RE: **2440 Louisiana NE**
Grading and Drainage Plan
Engineer's Stamp Date: 10/9/19
Hydrology File: H19D084

Based on the submittal received on 10/10/19 the above-referenced Grading and Drainage Plan is approved for Grading and Paving Permit.

2440 LOUISIANA
DRAINAGE MANAGEMENT PLAN

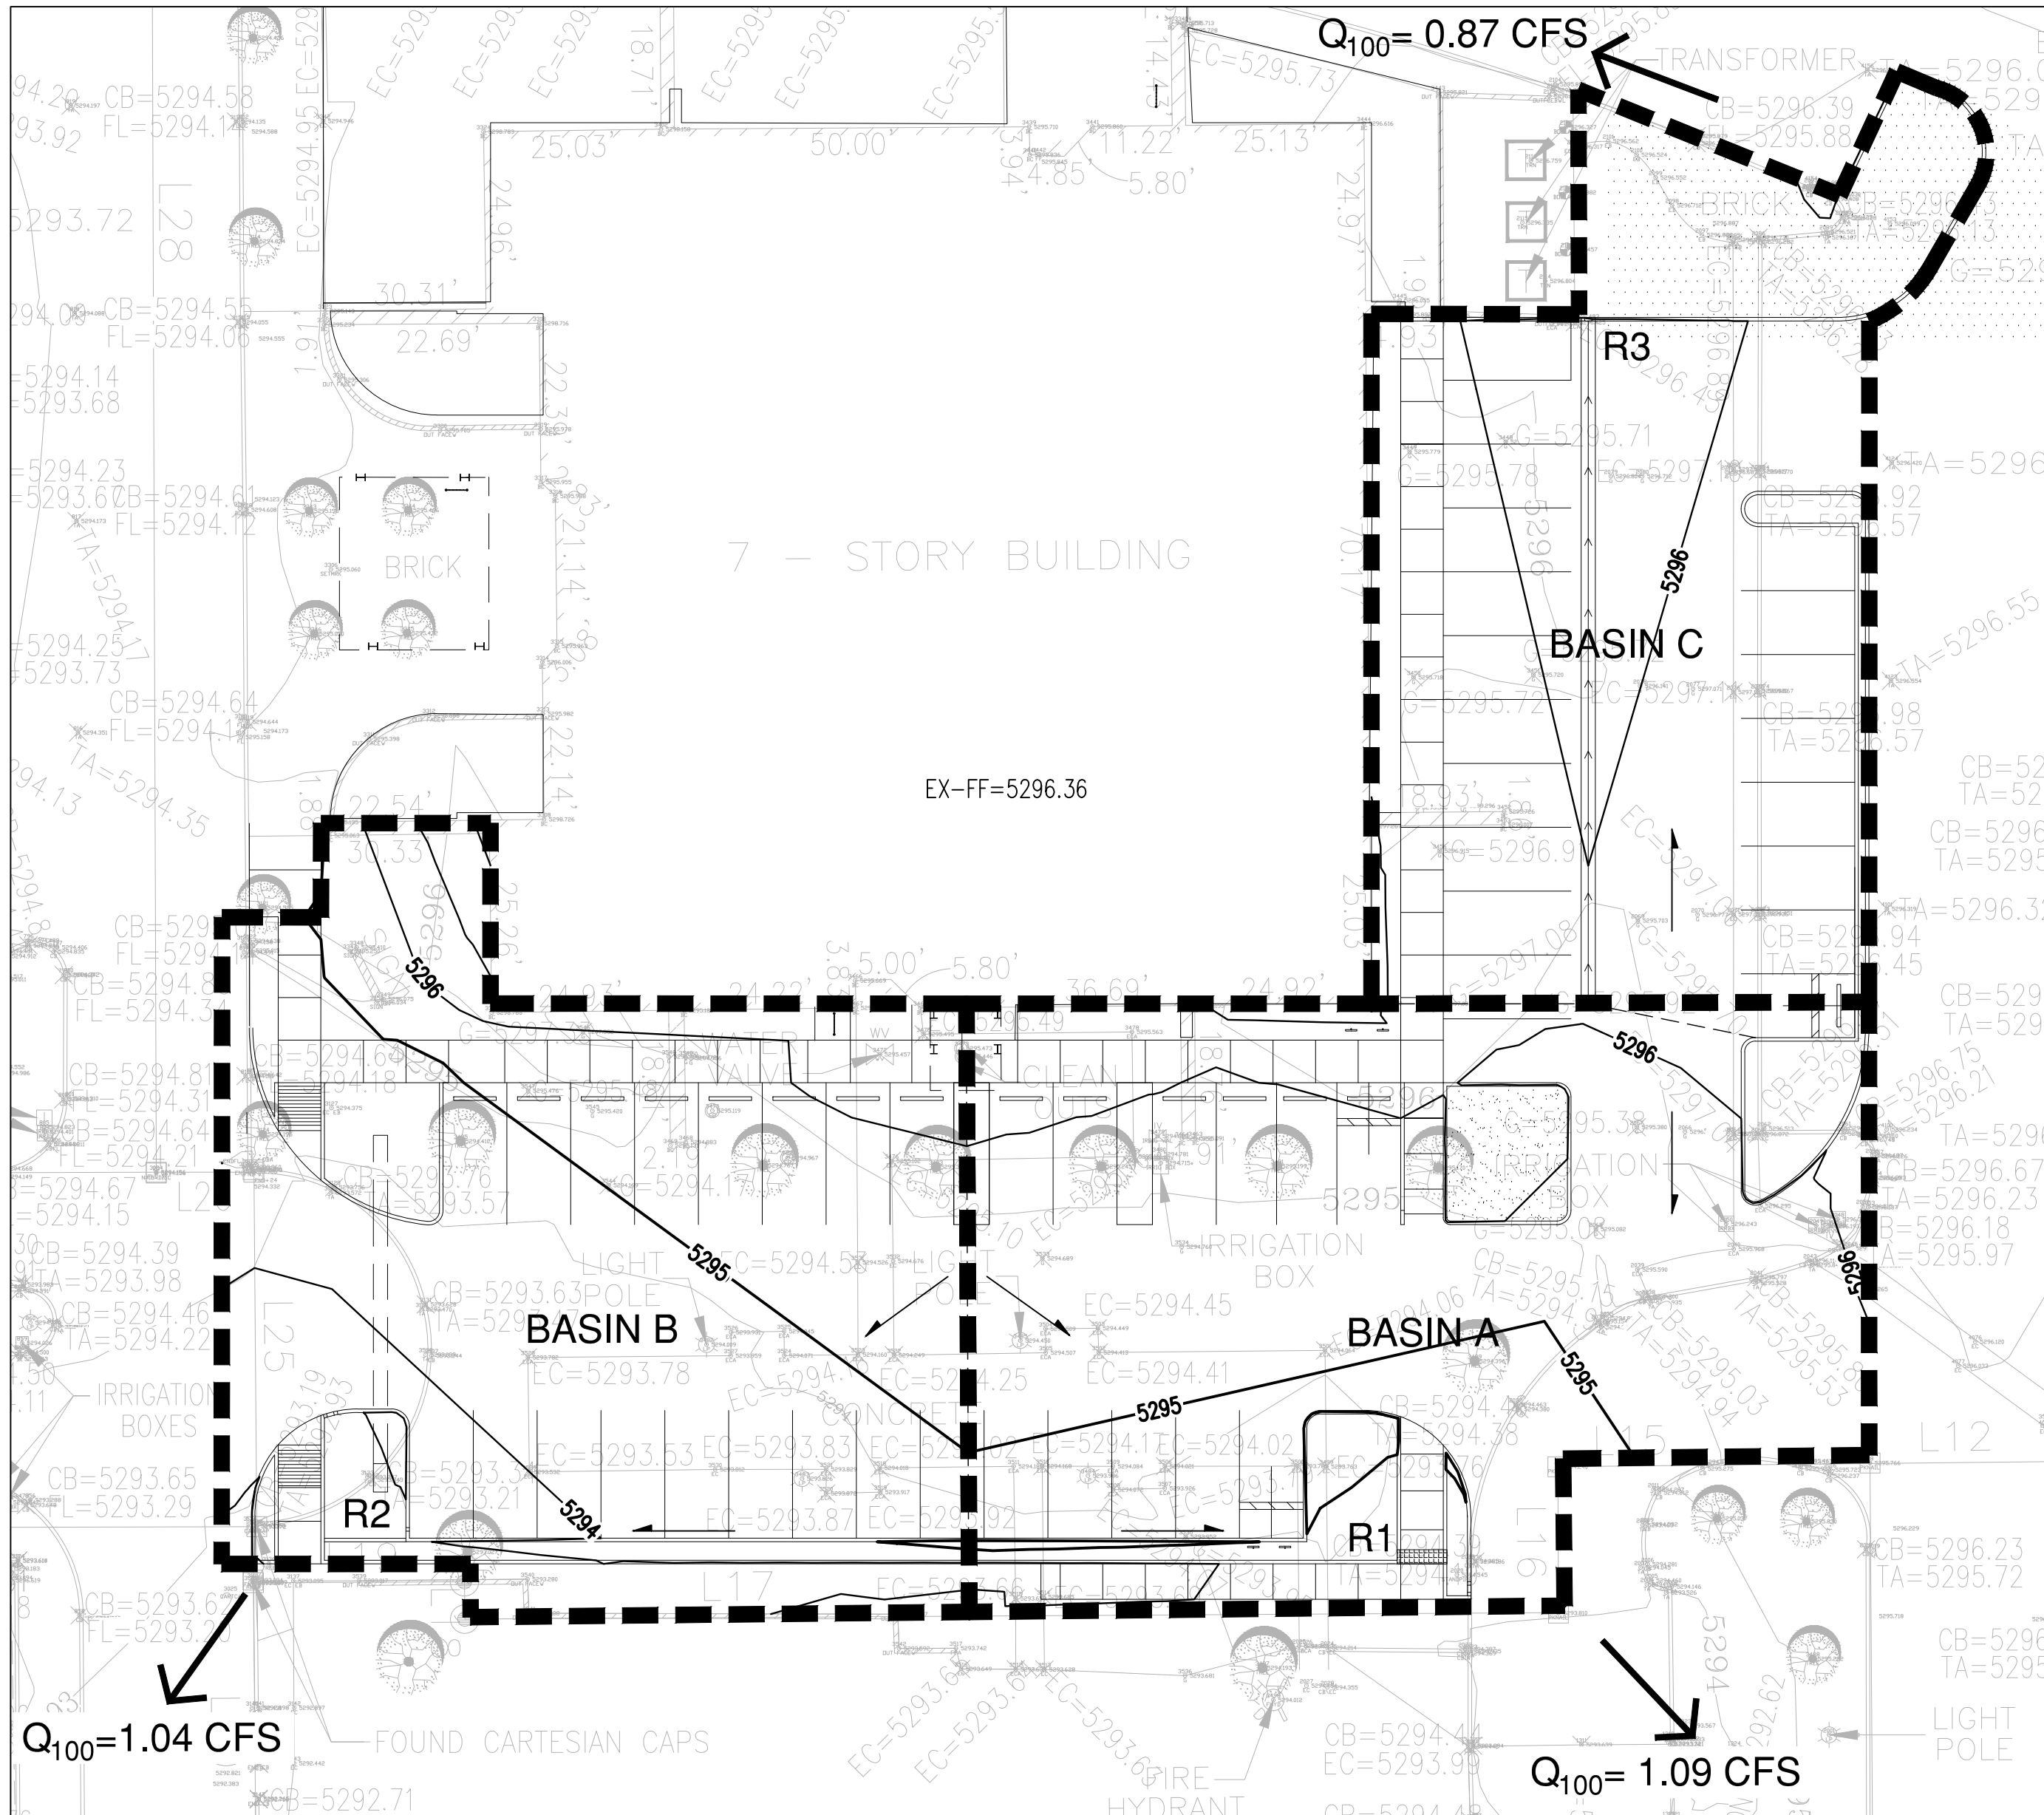
1. Engineer's Certification, per the DPM Chapter 22.7: *Engineer's Certification Checklist For Non-Subdivision* is required and needs to include photographs of the replaced orifice plates.
